UNITED STATES PATENT AND TRADEMARK OFFICE

APPLICATION NO.	FILING DATE	FIRST NAMED INVENTOR	ATTORNEY DOCKET NO.	CONFIRMATION NO.
10/849,299	05/20/2004	Tamaki Koide	13061-1	5595
23838	7590	06/08/2006	EXAMINER	
KENYON & KENYON LLP 1500 K STREET N.W. SUITE 700 WASHINGTON, DC 20005			KRAUSE, JUSTIN MITCHELL	
			ART UNIT	PAPER NUMBER
			3682

Office Action Summary	Application No.	Applicant(s)	
	10/849,299	KOIDE, TAMAKI	
	Examiner	Art Unit	
	Justin Krause	3682

DETAILED ACTION

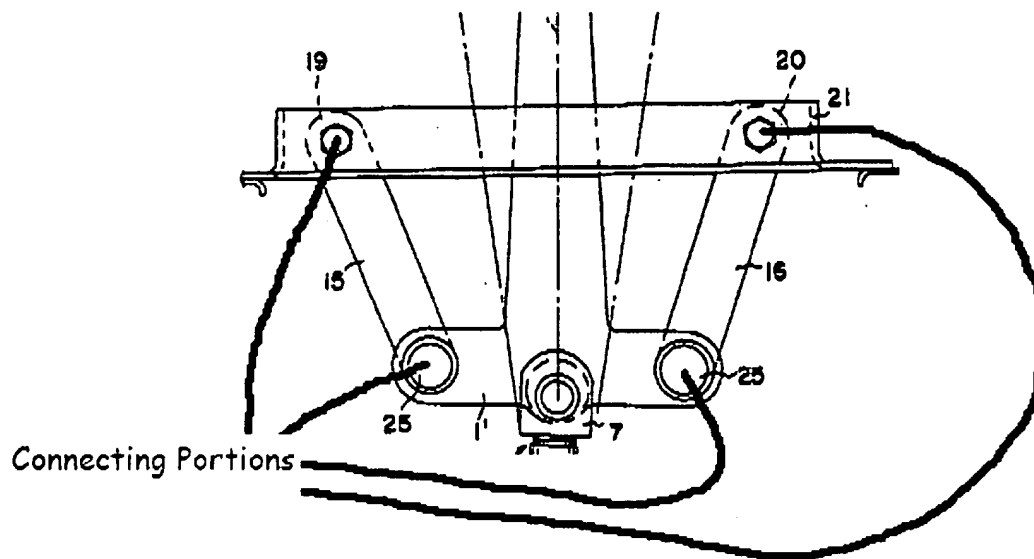
Heizmann discloses a shift lever apparatus comprising:

-a base member (23)

-a shift lever (1)

-at least one planar four bar linkage (21,15,16,1') supporting the shift lever

Regarding claim 2, the planar four bar linkage includes a base-side link element (21), a lever side link element (1') opposing the base-side link and a pair of connecting elements (15,16) connecting the lever-side and base-side link element, the shift lever is supported by the lever-side link, the base member supports the base-side link.
